SUBJECT: Forwards open items from Structural Engineering Branch
 811005-08 meeting in Woodbury, NY.

Subject: NUCLEAR PROJECT NO. 2
OPEN ITEMS FROM SEB MEETING

Attached are sixty copies of the open items from the Structural Engineering Branch meeting held in Woodbury, New York, October 5 - 8, 1981.

WNP-2
NRC-SEB MEETING

FIGURE
130-056-2

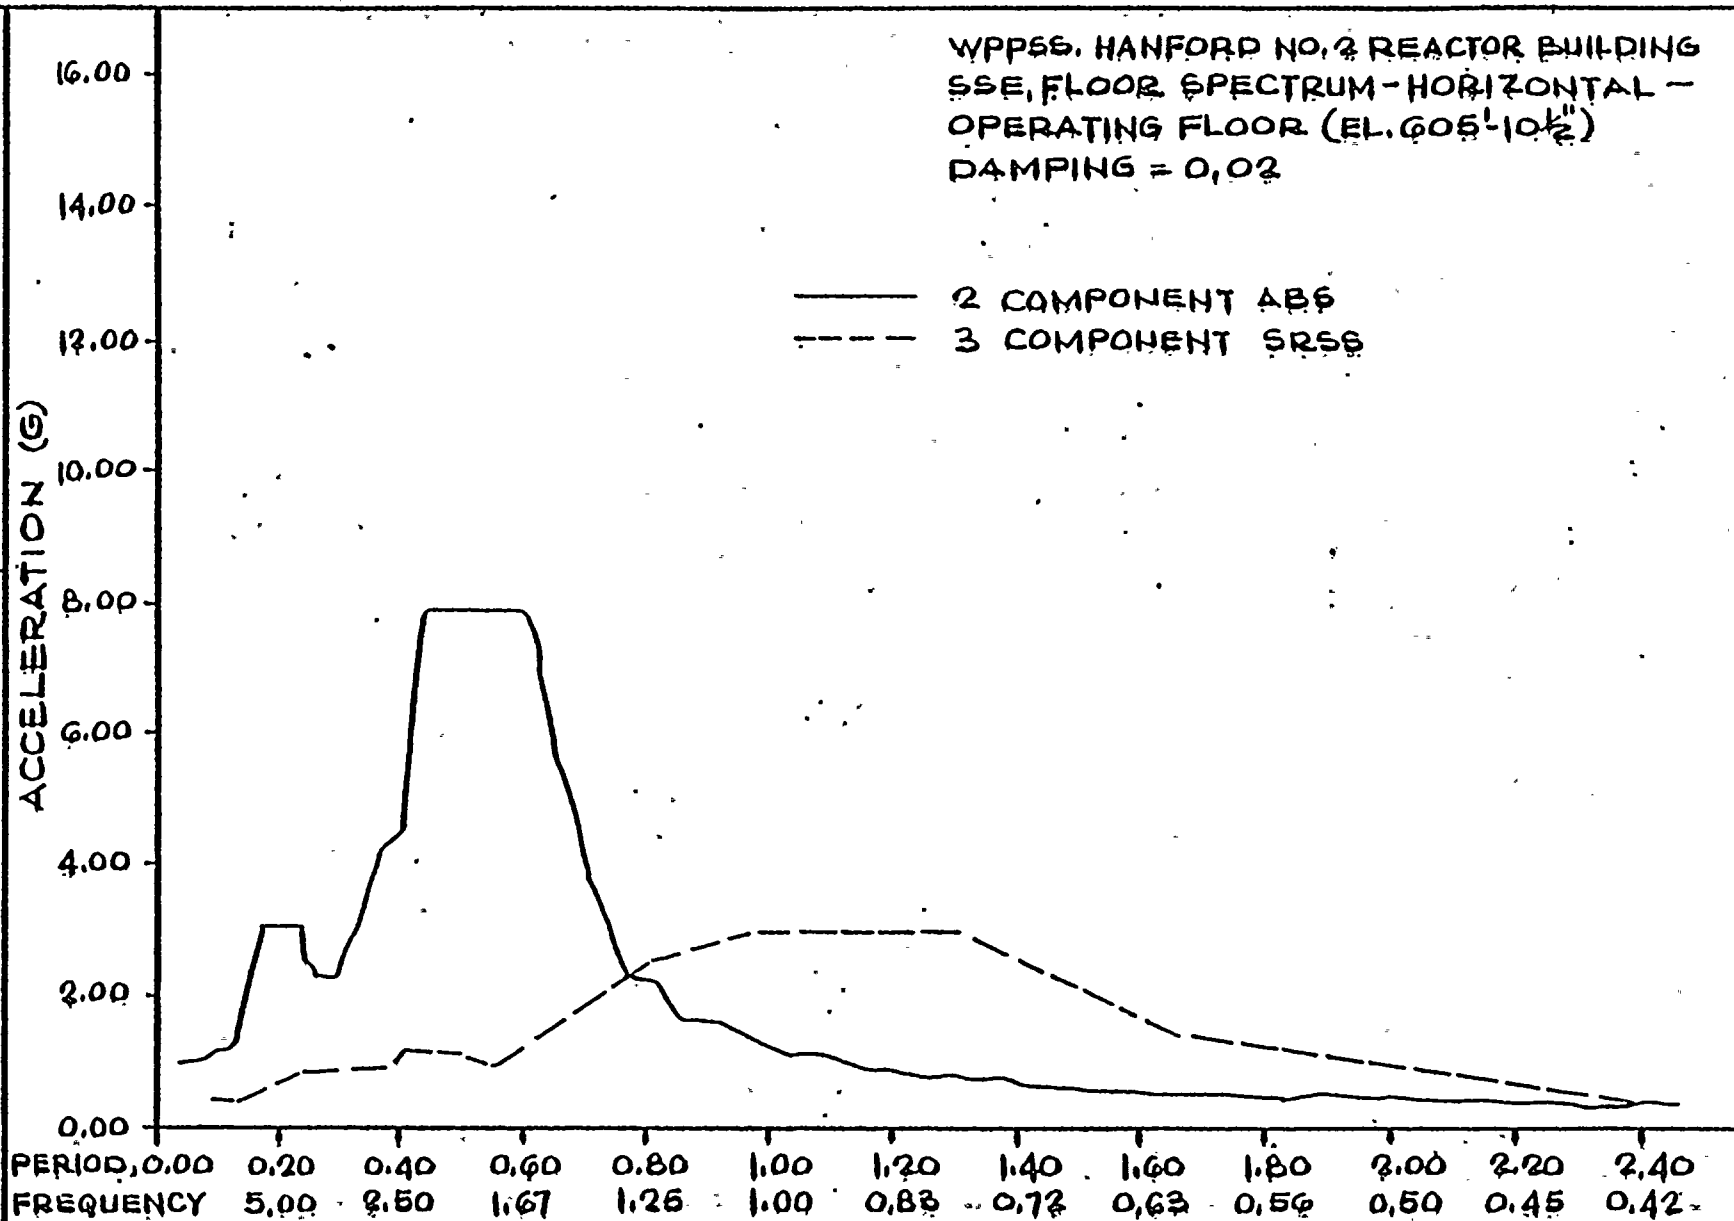
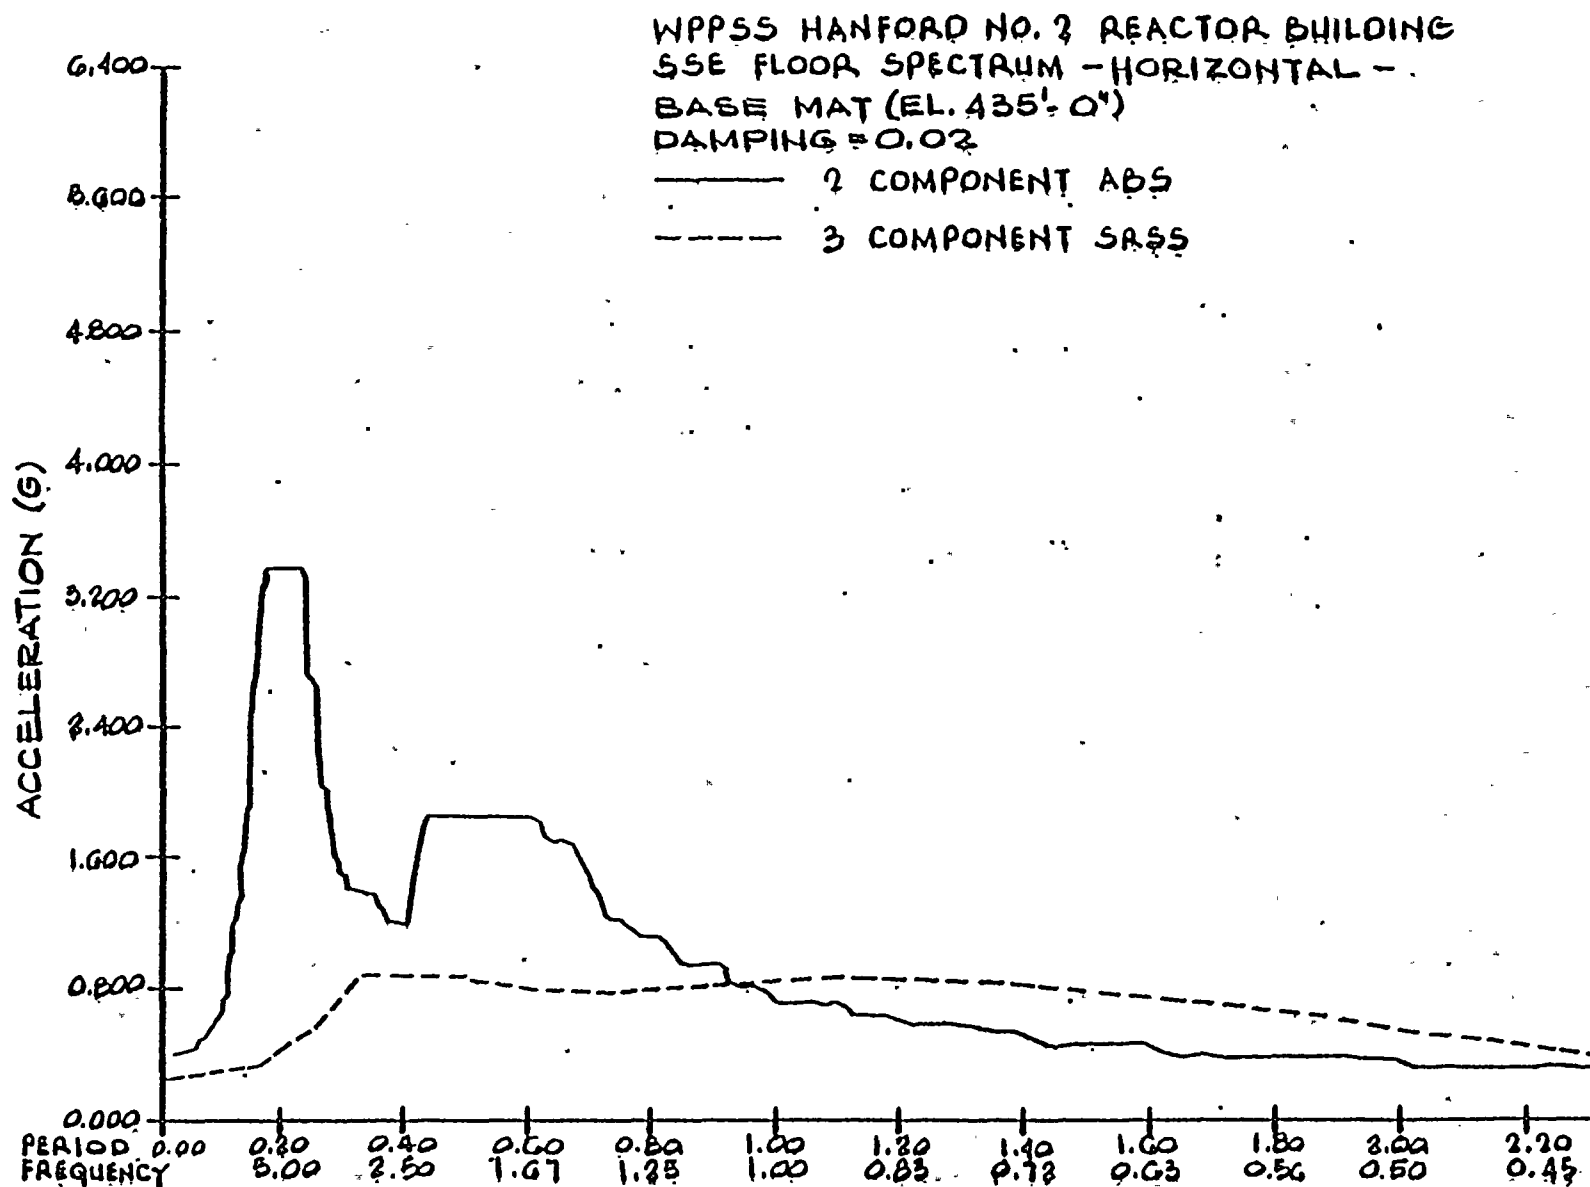
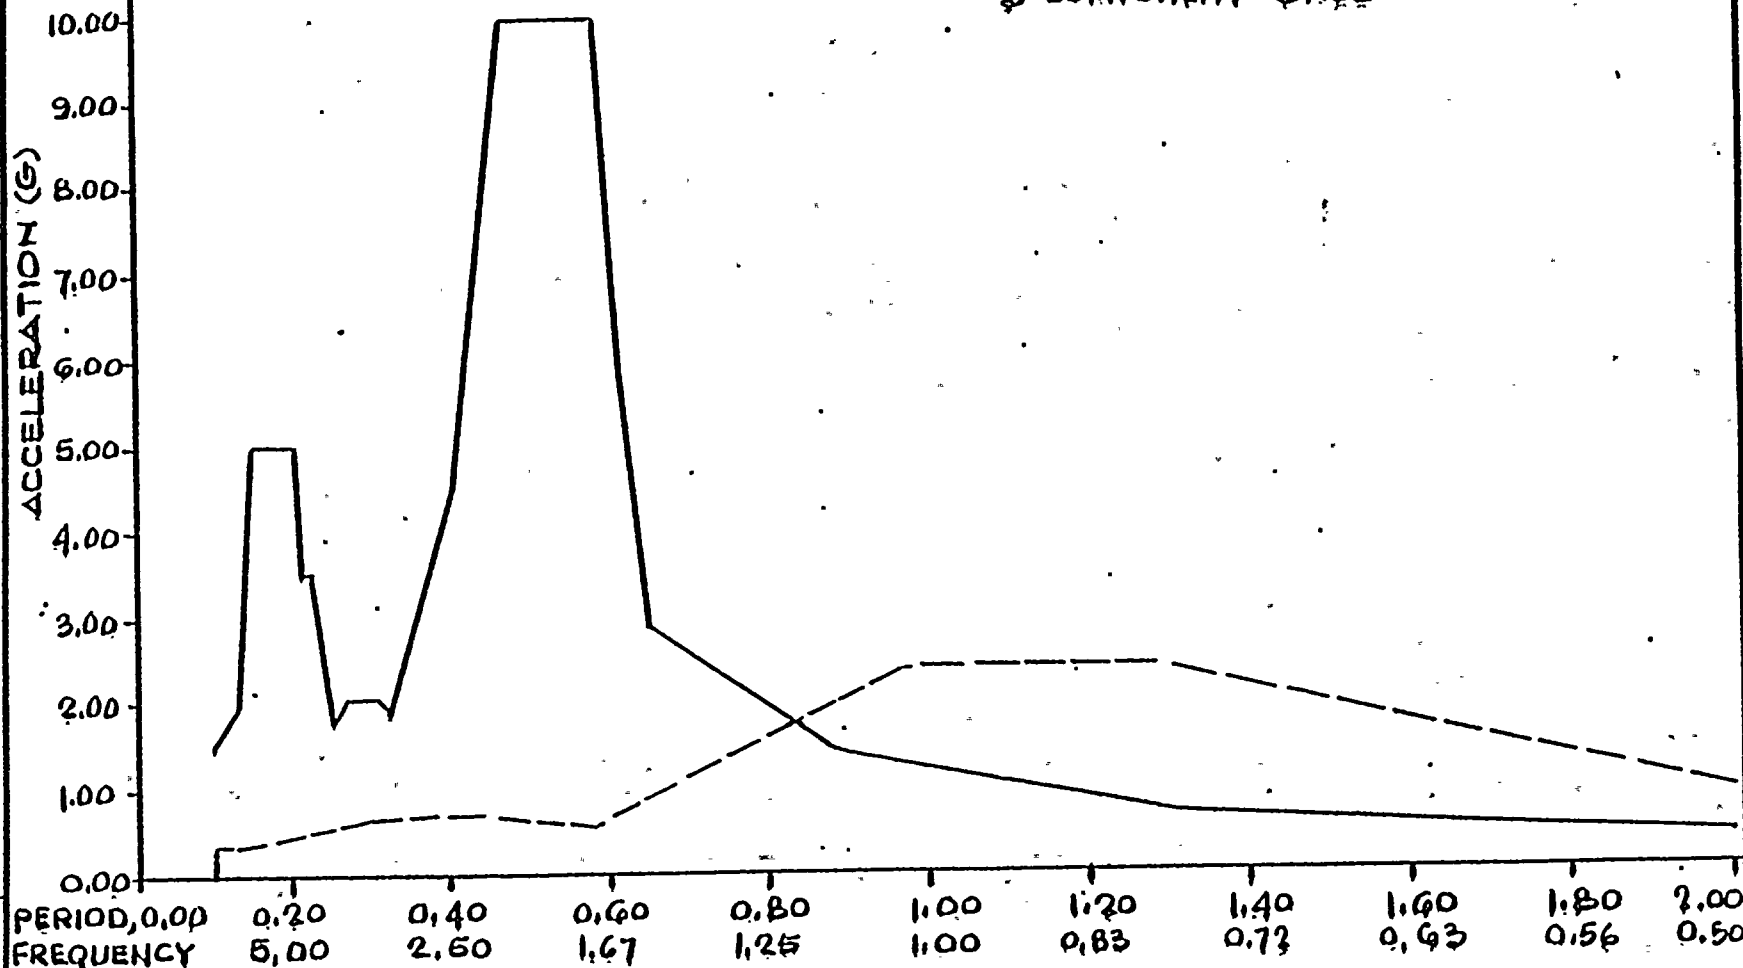
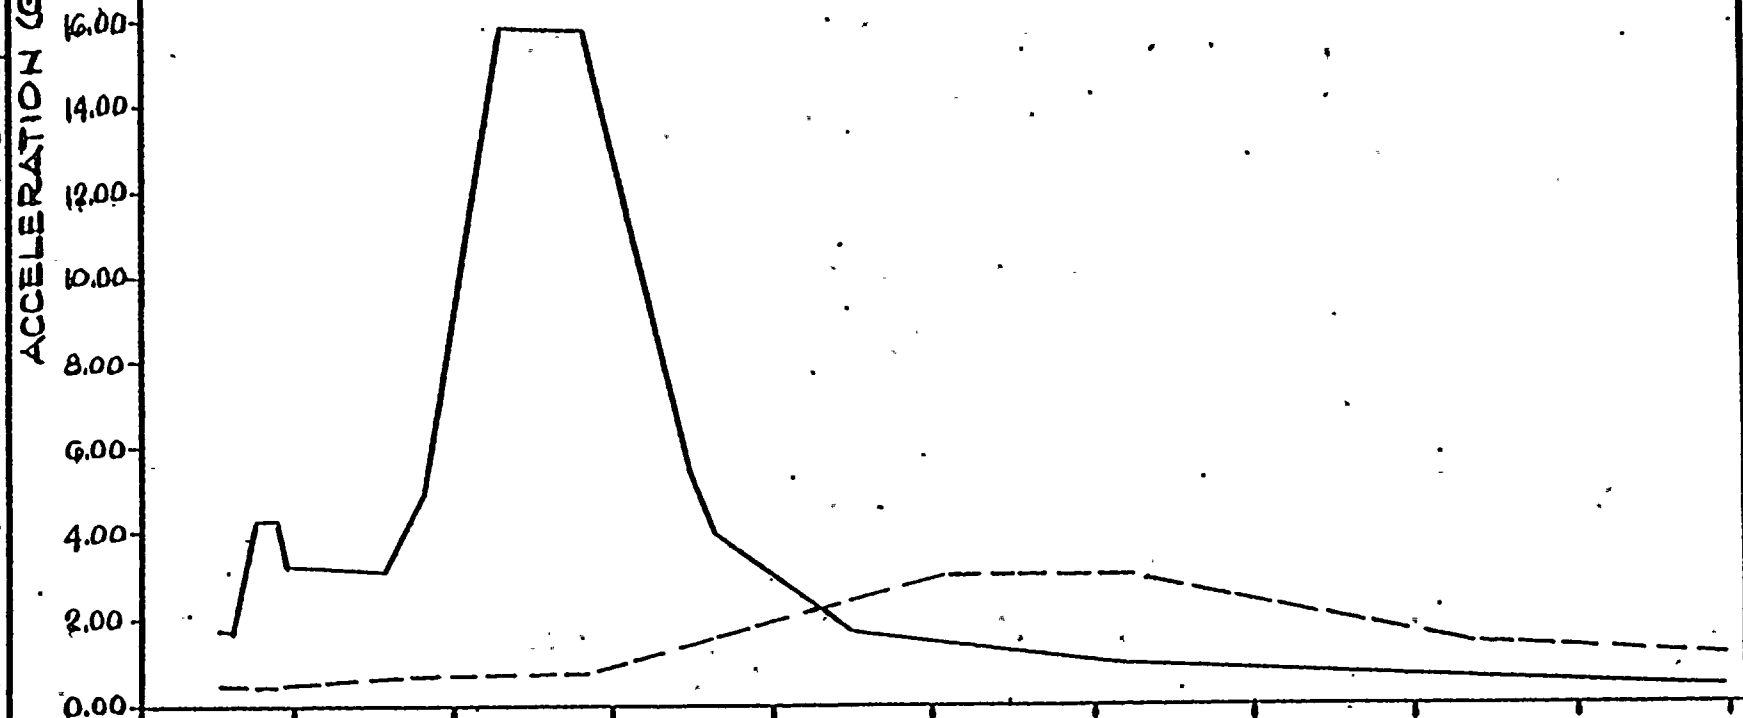
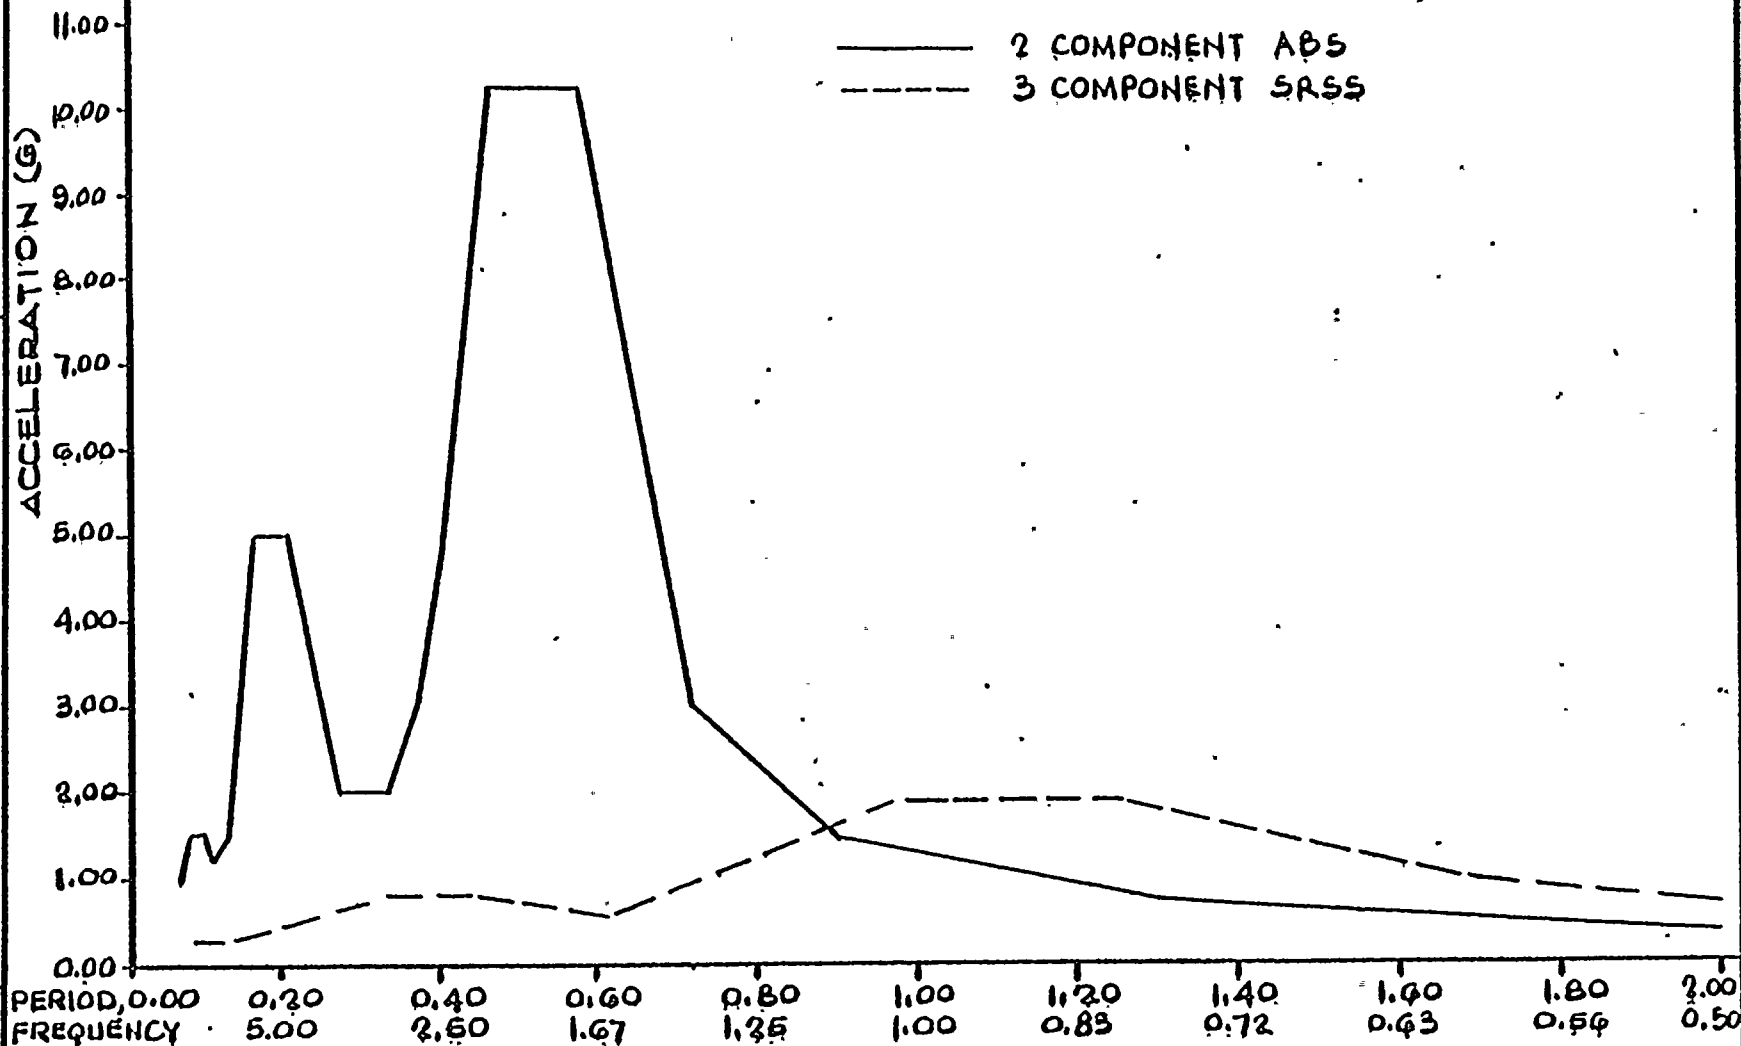
A comparison of building response spectra between the two component earthquake motion (absolute sum method) and the three component earthquake motion (SRSS method) are provided in Figures 130.056-1 through 130.056-7 for the following locations:

The comparison of response spectra clearly demonstrate that the original design basis (2-D method ABS) is more conservative than the SRSS/3 component method for all frequencies larger than 1.25 Hz. In the frequency range of interest/concern in the WNP-2 design (approximately greater than 5 Hz) the margin of conservatism is very significant.
